Appl. No. 10/731,496
Amdt. dated April 4, 2007
Reply to Office action of March 13, 2007

AMENDMENT TO THE DRAWINGS

Annotated Drawing Sheet

Fig. 4

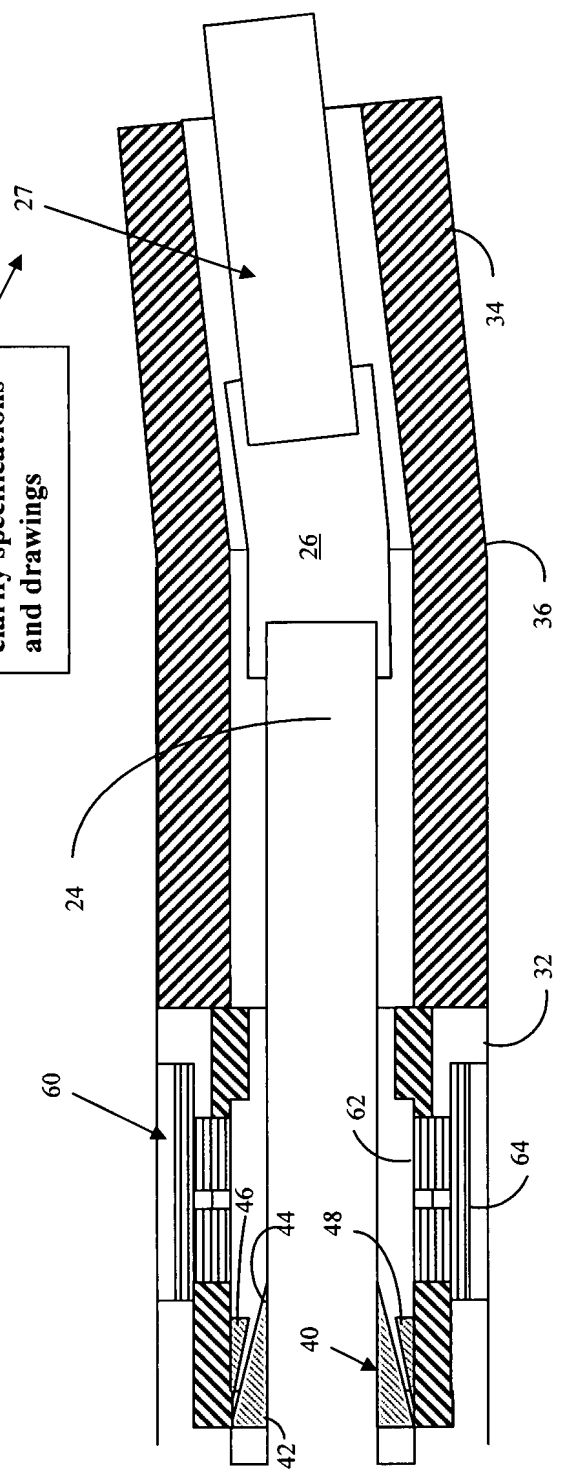
- Fig 4.
 - Numerical call out for Item 27 was inserted to provide clarity

Inserted Item 27 to
clarify specifications
and drawings
